RE: S/D 99-54 -- One-Step Final Plat of HOSKINSON 2nd ADDITION

STAFF REPORT

CASE NUMBER: S/D 99-54 - HOSKINSON 2ND ADDITION

VICINITY MAP

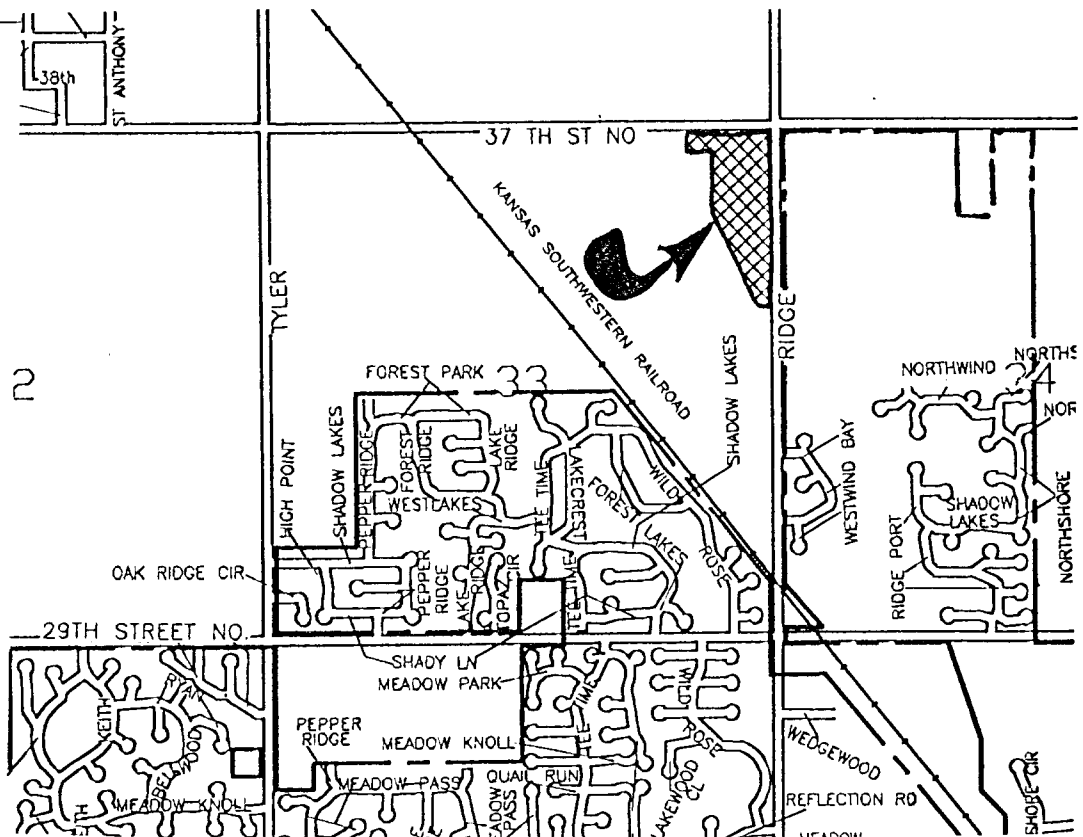
- C. The site is currently located outside of the Northwest Wichita Sanitary Sewer growth limits. The Applicant shall guarantee the extension of City water and sanitary sewer to serve the lots being platted. An additional utility easement is needed along the north line of Lot 4 or along the south line of Lot 2, for the sewer extension to Lot 9. .

- N. Dimensions need to be added for the west lines of Lots 1, 2, 3, 4, and 9; the north line of Lot 1, the south line of Lot 9 and the sewer easement on Lot 8.

- Q. The platlor's text shall note the platting of "Lots and a Block".
- R. The legal description needs to be revised to accurately denote the bearings for the north and east line of the section.

- S. The location and elevation of on-site and off-site benchmarks should be provided.
- T. County Fire Department has requested an increase in width of the 30-ft access openings to 40 feet.
